SUBJECT: Request for Concurrence on the Five-Year Review Document for the Idaho National Engineering and Environmental Laboratory, Naval Reactors Facility, Waste Area Group 8, Operable Unit 8-08

SUBJECT: Five-Year Review Document for the Naval Reactors
Facility OU 8-08 Sites

Five-Year Review Document
for the
Naval Reactors Facility
OU 8-08 Sites

Figure 3 Grids where PCB was detected

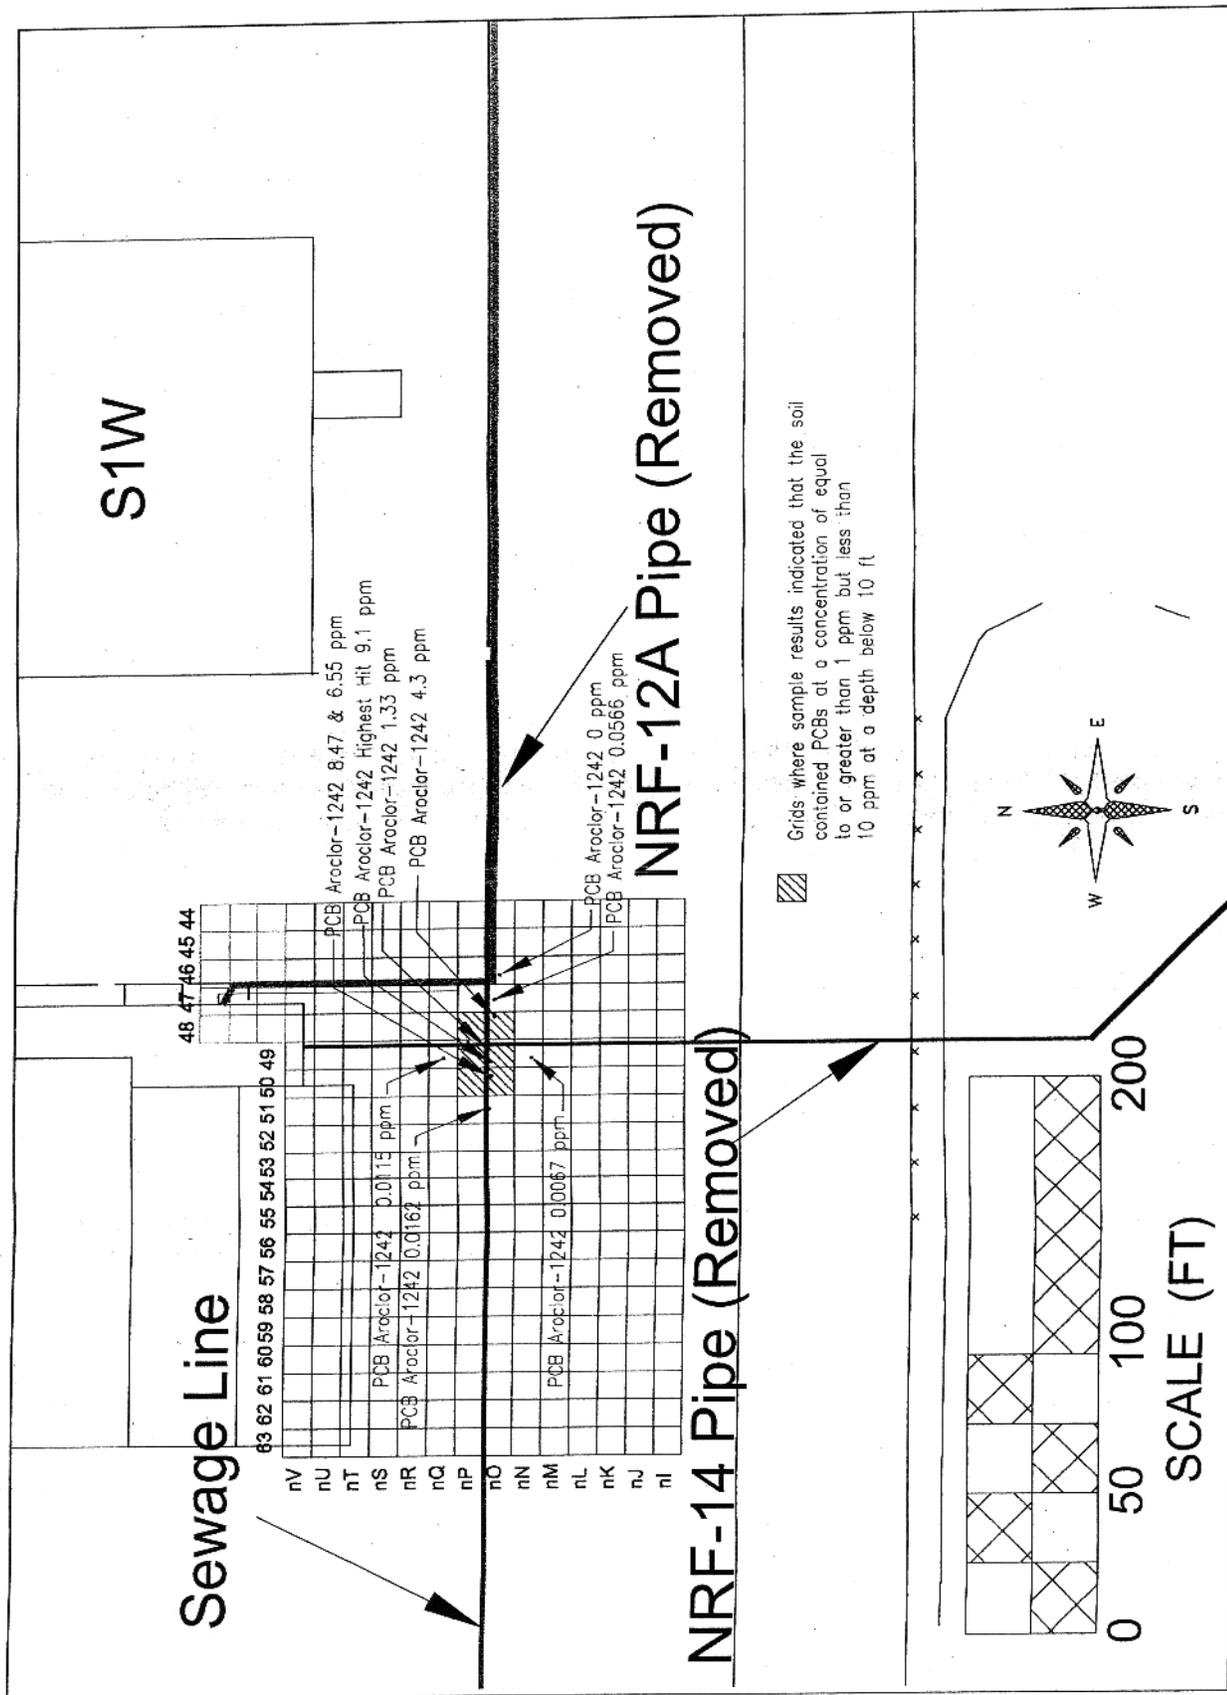
13. Section 3.5.2, Page 11, third paragraph [now Section 4.2, page 16]: The location of the remaining PCB contamination should be presented in a figure, and the remaining contaminant levels should be listed. Also, PCB levels for "minimum low occupancy" and "industrial" are not the same.

Response: A new figure (Figure 3) was added to the document showing the location and concentrations of the remaining PCB contamination. The words "industrial occupancy" were dropped from this section.
